Re: Response to Sydney North Planning Panel Deferral Notice (PPSSNH-506 – DA2024/106)

Gyde Consulting act on behalf of the applicant SJD NB Pty Ltd., regarding the proposed development application (DA-2024/106) at 57-69 Strathallen Avenue, Northbridge. We write in response to the 'Record of Deferral' Notice issued by the Sydney North Planning Panel (the Panel), dated 5 June 2025.

DRAWING TITLE:
SWEPT PATH ANALYSIS - 10.6M
WASTE VEHICLE ENTERING
AND EXITING - GROUND FLOOR
WITH 2.0M ACCESS FROM
GENERAL WASTE STORAGE

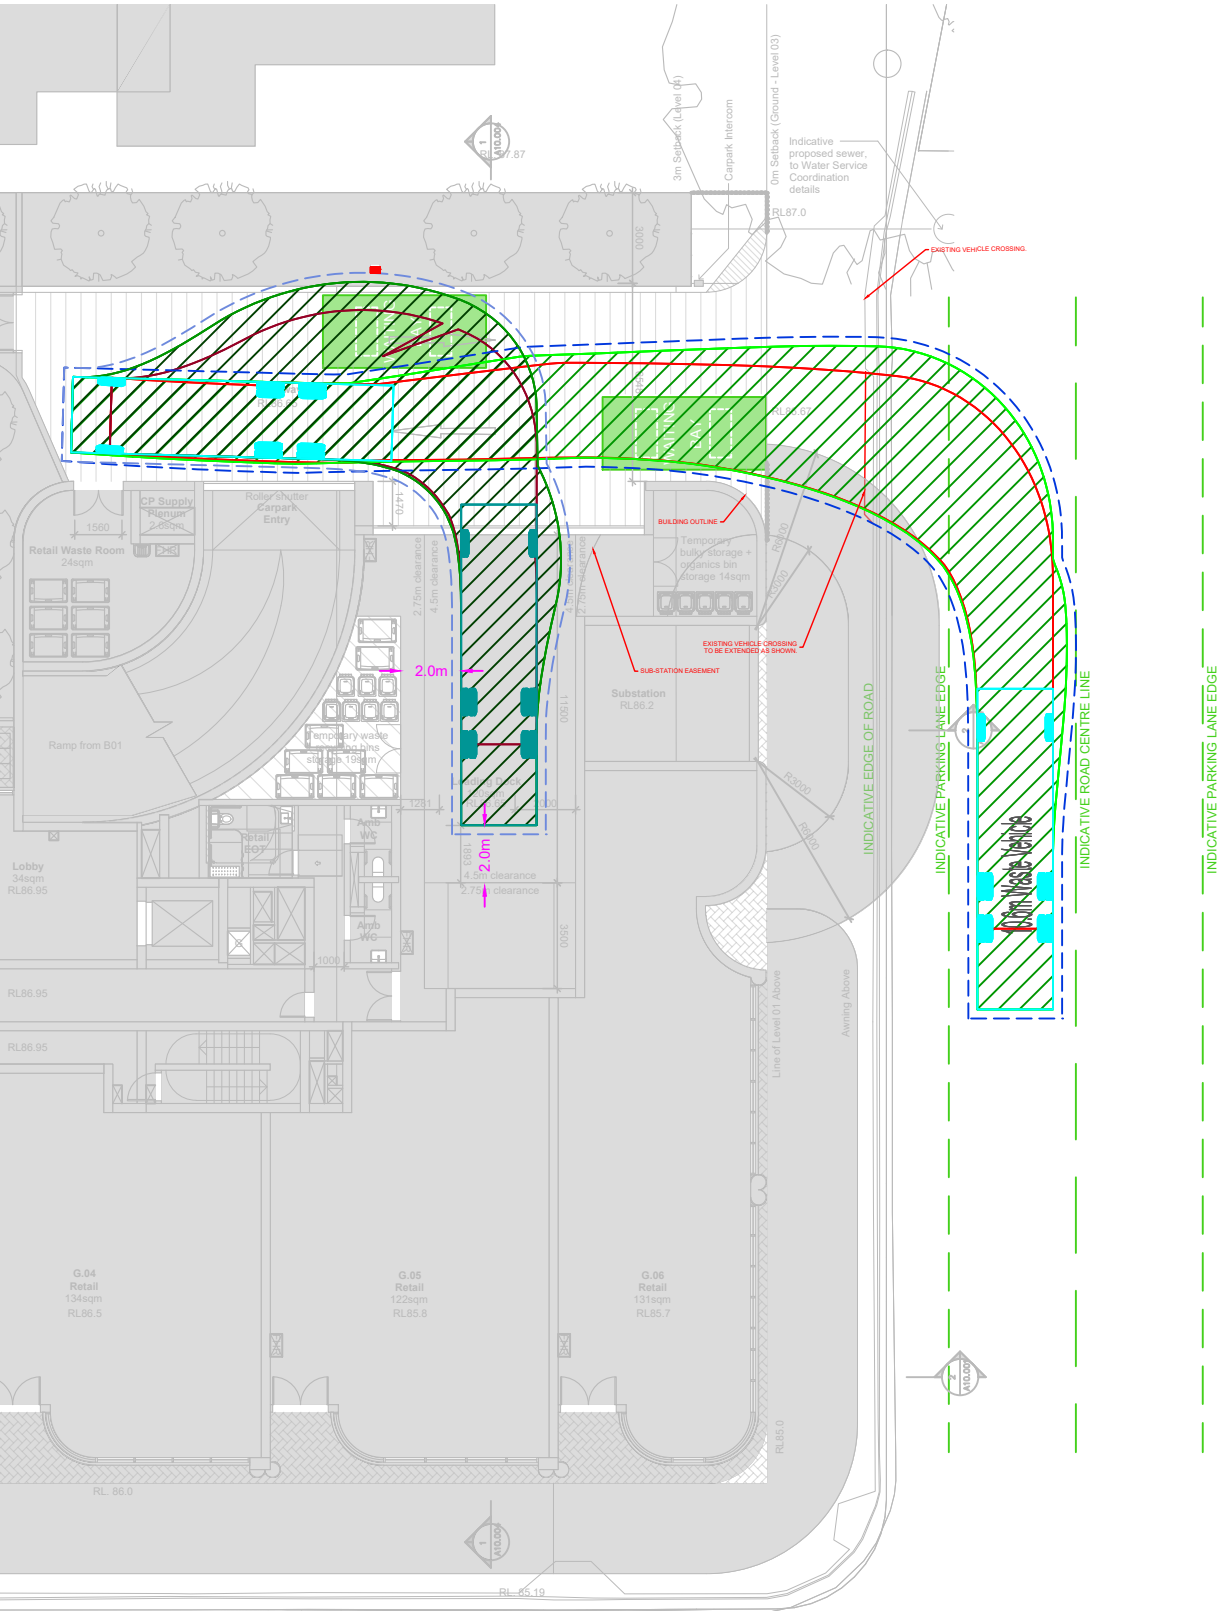
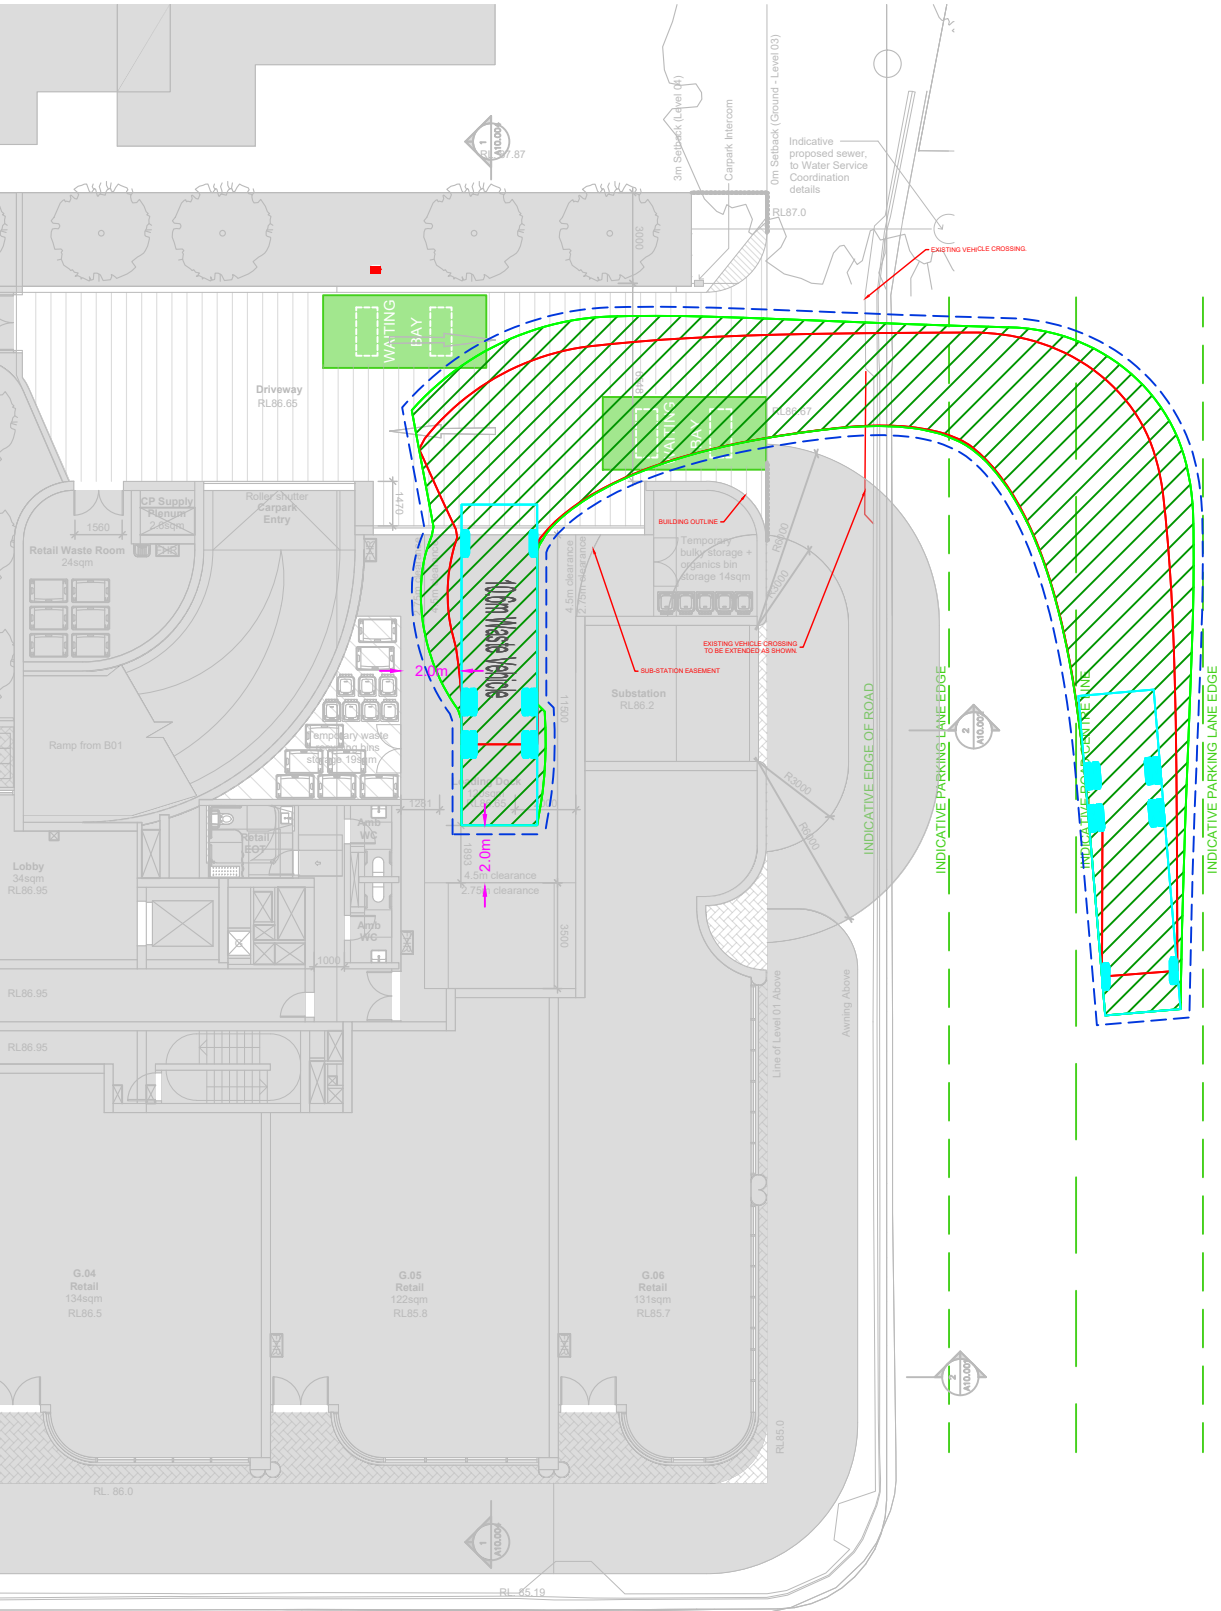
However, I think you need to show another swept path that the truck can park with 2m side access to main bin room. That room is blocked in based on the swept path shown.
